RESPONSE TO EDITOR AND REVIEWERS' COMMENTS:

Authors' General comment: Thank you for the Editor and Reviewers' constructive comments concerning our manuscript entitled "Sensitivity analysis of a built environment exposed to debris flow impacts with 3-D numerical simulations" (ID: nhess-2022-173). We have the greatest respect for your professional opinions on the debris flow hazard. Reviewers' comments are all valuable and very helpful for revising manuscript and improve the future research. We have studied comments carefully and have made corrections which we hope meet with approval. Revised portions are marked in red in the paper and response letter, and the manuscript is re-submitted in clean format to the Journal. Please also find below my response to Reviewer's comments.

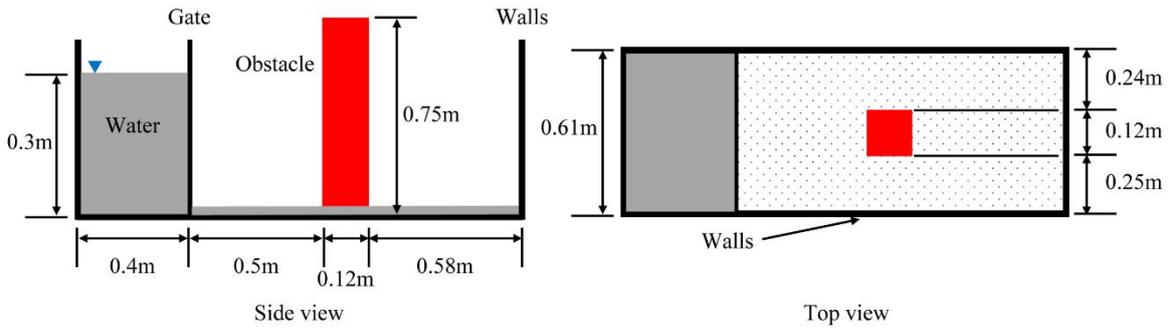
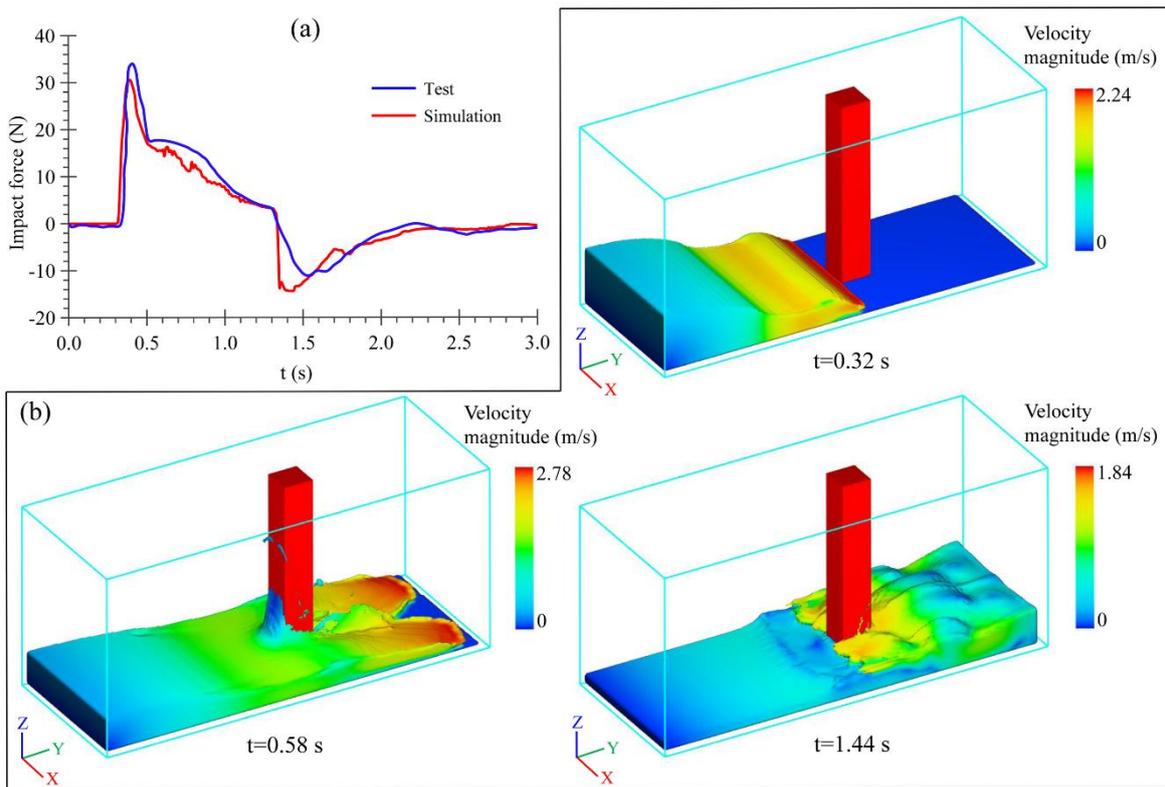
[RC3] 1. The main one concern the validation. In the laboratory experiment used for the validation, a well-mixed stony granular debris flow is reproduced. One of the main characteristics of this debris flow is that the energy dissipation is due to the collision between the particles and not by the viscosity of the fluid (e.g. Iverson 1997, Takahashi 2007, Armanini 2013). However, in the

[RC3] 2. Another point of the validation part regards why the authors do not show the time history of the impact force. Since one of the characteristics of a debris flow impact process is its dynamic changes in time as the experiments of Song et al. 2021 show (the time history is quite complex and is not only represented by a single value!), the "simple" peak value is not sufficient for validating the model used. For this reason, I think that the authors' response "It is demonstrated that the RNG and GMO coupled model in FLOW-3D are able to describe the peak impact force and fluid surface effectively" is not fully trustable.

(2) Response to comment: “It is important also the time history of the pressure. And why the authors do not show the time history of the impact force?”

AUTHORS RESPONSE: We greatly appreciate for Reviewer's good comments! As Reviewer suggested, we have selected another classic dam-break experiment for the validation of fluid-structure interaction (Gomez-Gesteira and Dalrymple, 2004; Liu et al., 2021). The new statements about the model validation were added in [Line 128-157](#) of the revised manuscript.

Fig. 2a shows the agreement of numerical forces obtained by means of the RNG and GMO coupled model with experimental data, particularly the positions of both peaks, which correspond to the wave hitting the front and the back of the structure and were reproduced perfectly by the numerical model. Fig. 2b shows the evolution of the wave generated by the dam-break and the initial layer of water on the bottom. At $t = 0.32$ s, the wave is colliding with the front of the obstacle. At $t = 0.58$ s, the wave is wrapping around the structure, colliding together and continues moving toward the tank wall. At $t = 1.44$ s, the reflected wave is hitting the back of the obstacle.

AUTHORS RESPONSE: Thanks for Reviewer's good suggestion! As above-responded, a new model validation has been executed, and the time history of impact force was determined to be compared, as shown in Fig. 2a.
